ITEM NO _____1____
MEETING DATE May 14, 2014
STAFF Holland
HEARING OFFICER

STAFF REPORT

PROJECT: Geico Office Building, Project Development Plan, PDP #130039 and Modification of Standard to Section 4.26(E)(1)

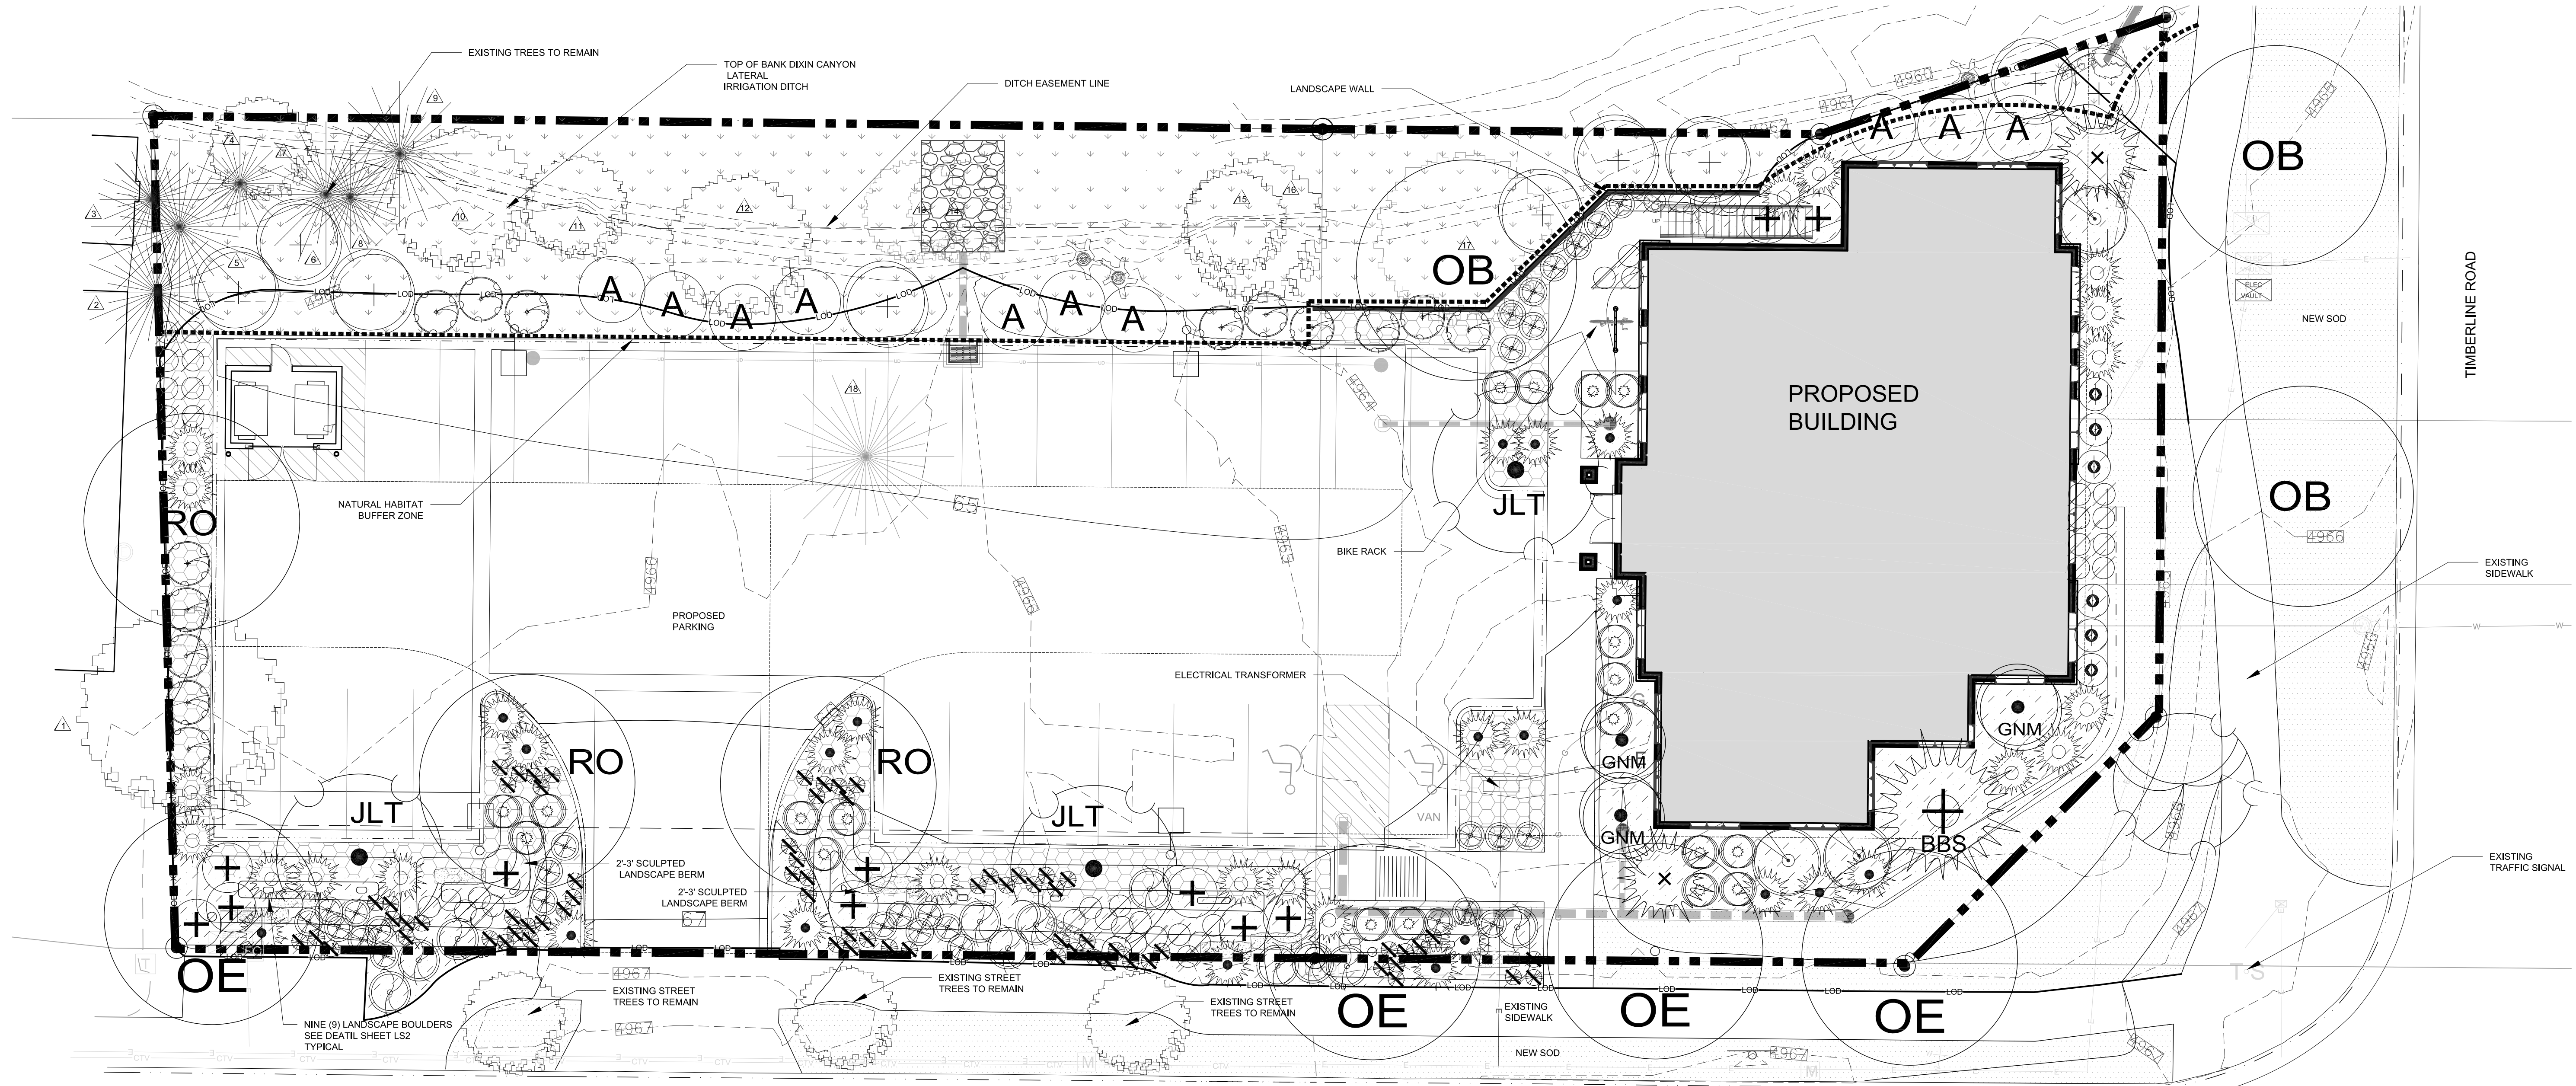
The modification requested is for the **Harmony Corridor Standards and Guidelines** "General Standards and Guidelines" section regarding the Harmony Road Setback. The requirement is for all new developments east of Boardwalk Drive must provide a minimum 80 foot setback from the future edged of pavement.

The property has several physical constraints. It is a shallow, 100' deep lot and the existing Dixon Canyon Ditch runs partially through the site, thus causing the parking area to be pushed towards Harmony Road. If the 80' setback were imposed, the remainder of the lot would be 35' wide, which would render the site infeasible.

Requested Modification: Given the above, we request that the proposed setback be 27 feet instead of 80 feet.

D. Staff Finding for the Modification:

Staff finds that the request for the Modification of Standard to Section 4.26(E)(1) *Harmony Corridor Development Standards* is justified by the applicable standards in 2.8.2(H). The granting of the Modifications would not be detrimental to the public good and:
